TOWN OF WINCHENDON

BOARD/COMMITTEE: **Planning Board – Regular Meeting &
PUBLIC HEARING - Continued**

1. Call to Order
 - Pledge of Allegiance
2. Announcements
3. Public Comment
4. New Business:
 - A. **6:35 pm - PUBLIC HEARING CONTINUED** - Site plan application for a 3.135 MW DC Ground-Mount Solar Development on property located at 185 Baldwinville Rd., (Map 13 Parcel 04). PAGE 2

Tighe & Bond has been retained by the Town of Winchendon to provide Peer Review Services to the Planning Board in their review of the Site Plan Review and Low Impact Design Permit Applications for the construction of a 3.135 MW photovoltaic solar array (the Project). The Project is located on an approximately 51.182-acre parcel of land located at 185 Baldwinville Road in the Town of Winchendon, Massachusetts. The property is located within the Rural Residential (R-80) zoning district, according to the latest Zoning Map, dated November 2, 2009. The Applicant, Sunpin Solar Development, LLC, has provided the following documents for review:

Figure 1: Red-line exhibit depicting amendments

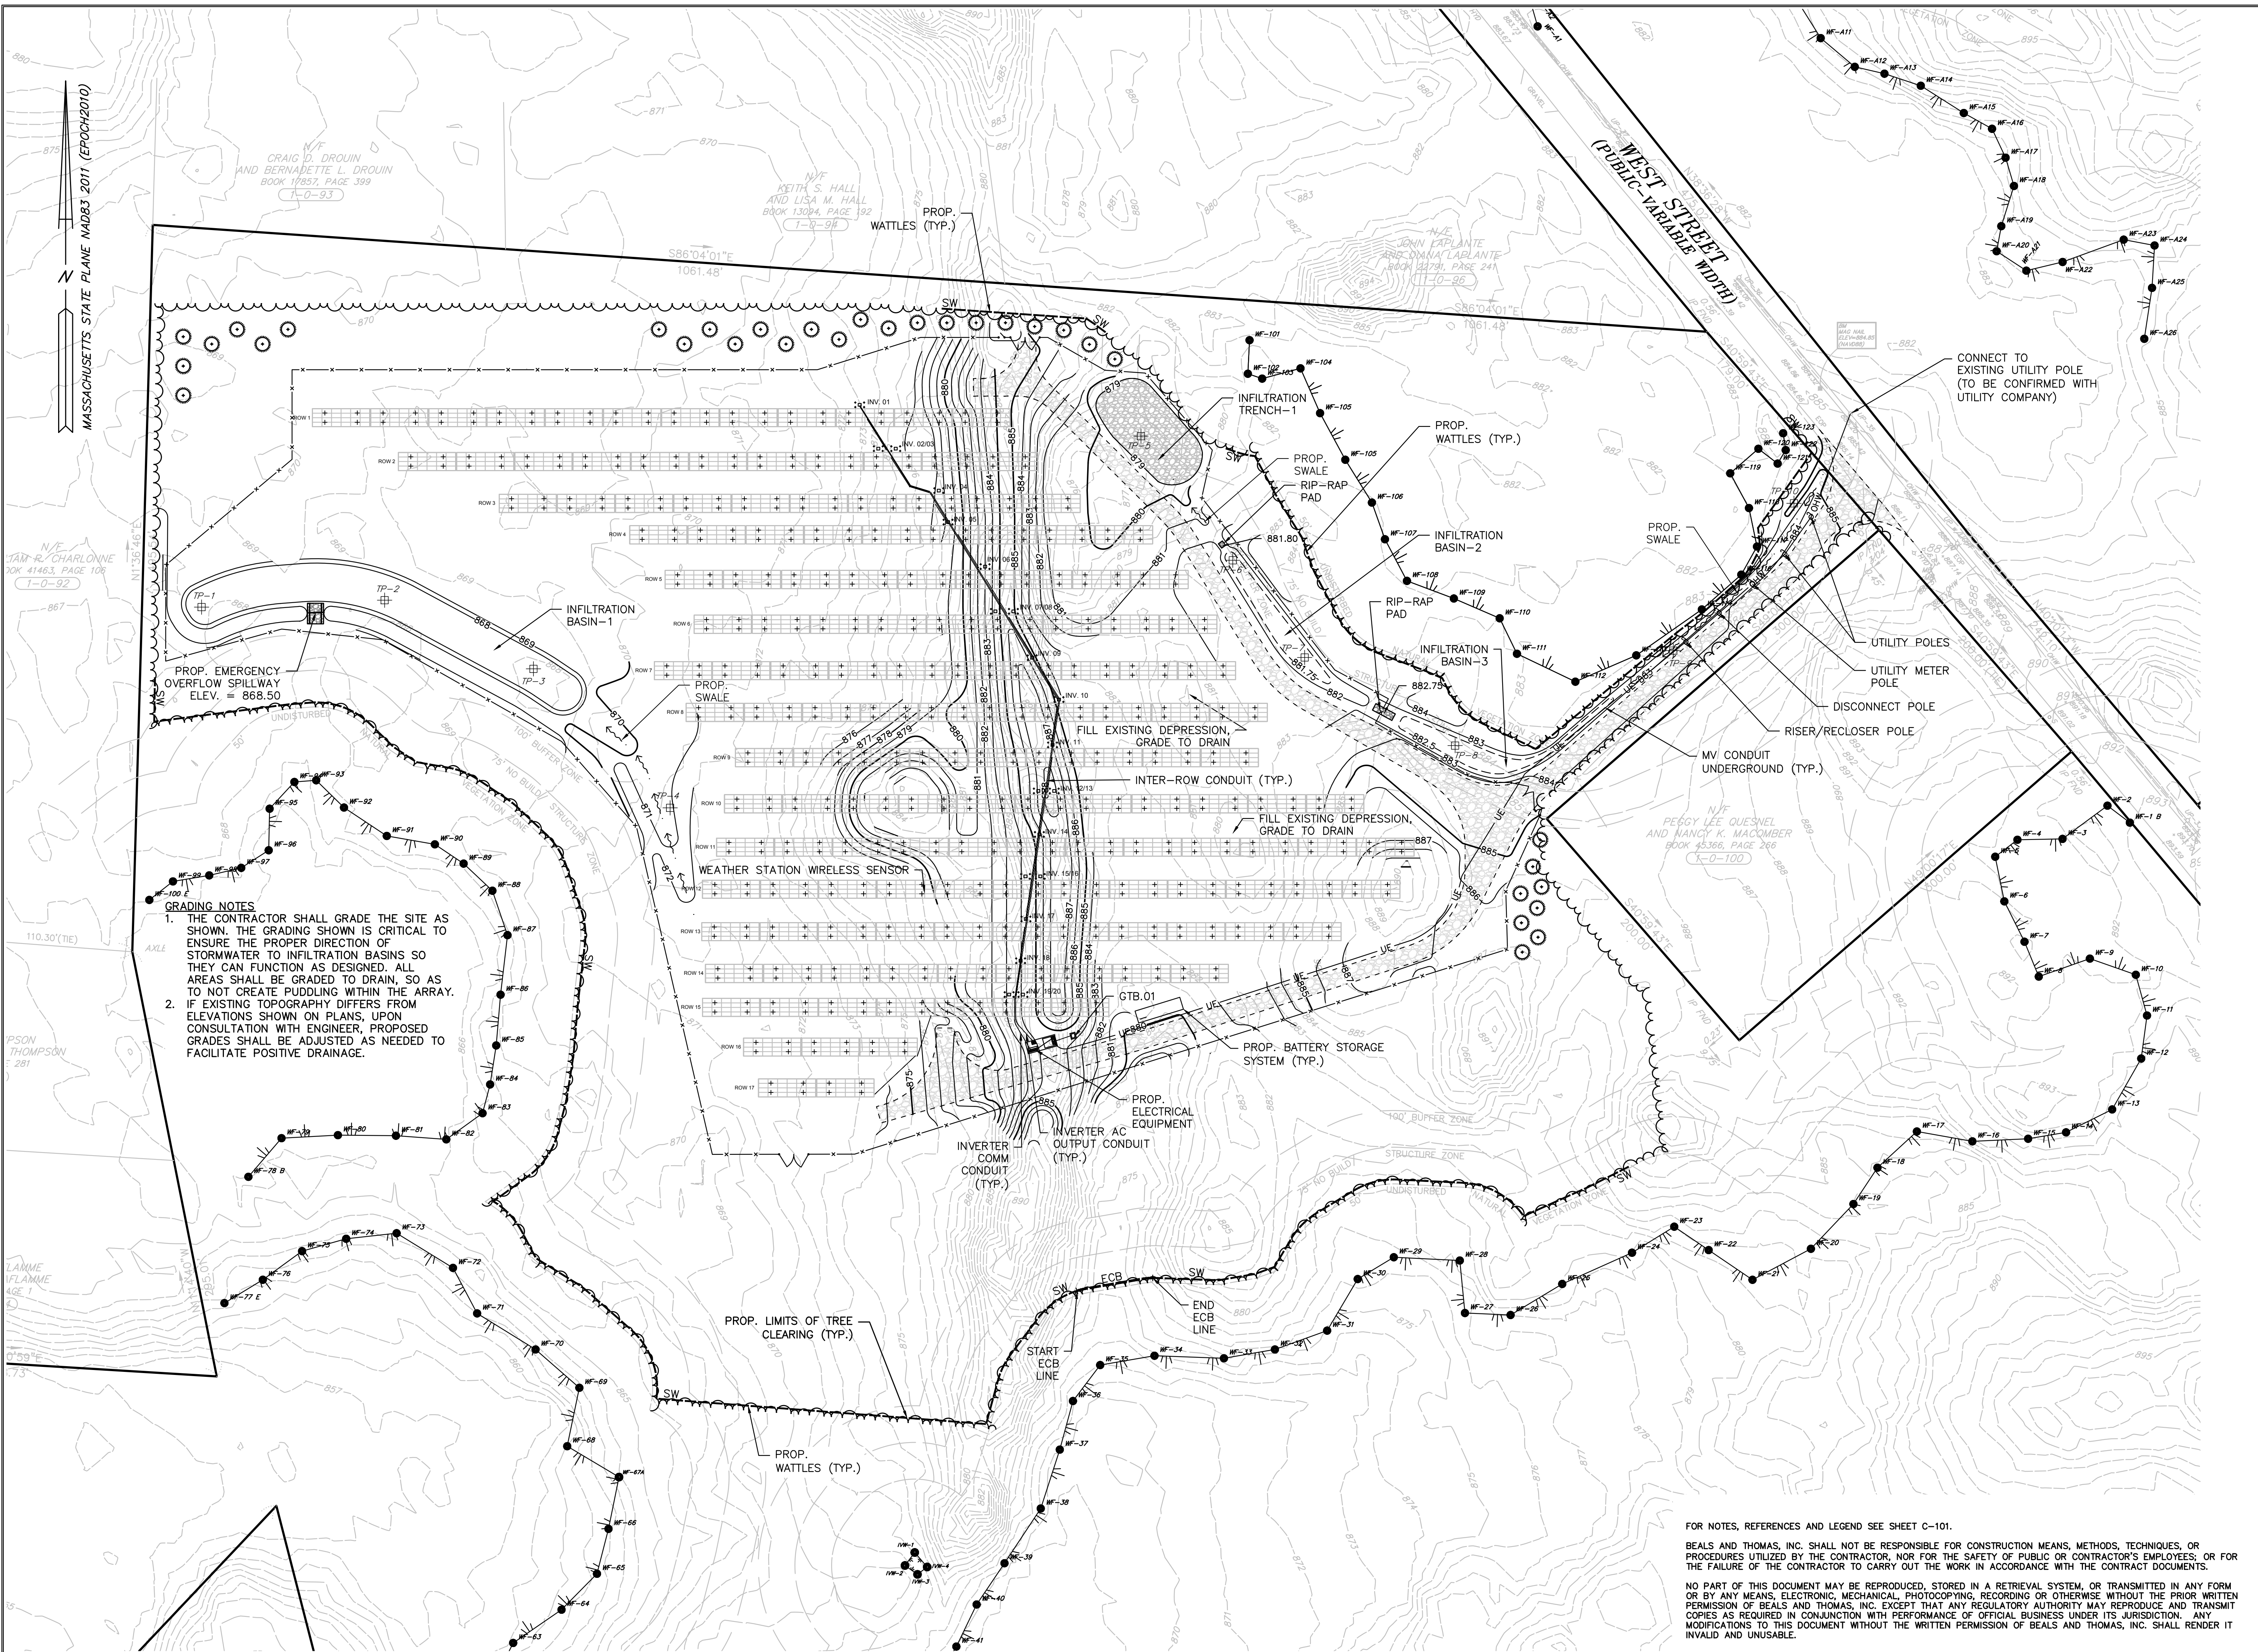
The Applicant currently proposes to add a battery storage system to the Project in an effort to more efficiently provide power to the electric grid. The battery system is capable of delivering 0.5 MW of energy over two hours, which helps to meet peak energy demands later in the day as solar production diminishes. The battery storage system would be housed within a metal enclosure slightly elevated on concrete footings, and will contain a fire detection and suppression system. Please refer to the documentation of the battery storage system components included in Section 2.0 for system dimensions, as well as the revised site plans enclosed in Section 4.0.

The proposed battery storage system will be located along the east side of the approved equipment pad in the central portion of the Property, directly adjacent to the array. It will be contained entirely within the previously-approved fenced area, outside of the 100-foot buffer zone to wetland resource areas. The battery storage system will be set back approximately 580 linear feet from West Street. The previously-approved screening along the northern and eastern boundaries of the array, consisting of 6- to 7-foot Eastern hemlock, will still provide screening such that additional aesthetic impacts are not anticipated.

In addition to the proposed battery storage system, the Applicant proposes minor adjustment to the array layout, as well as the number and location of the interconnection utility poles along the access road, as depicted on the enclosed revised plans. The locations of these poles as currently depicted were specifically requested by National Grid, which will own and maintain the poles. The poles are located no closer to wetland resource areas than their approved locations. The minor adjustments to the pole number and location is not anticipated to increase visibility of the interconnection from West Street. As such, no new aesthetic impacts are anticipated.
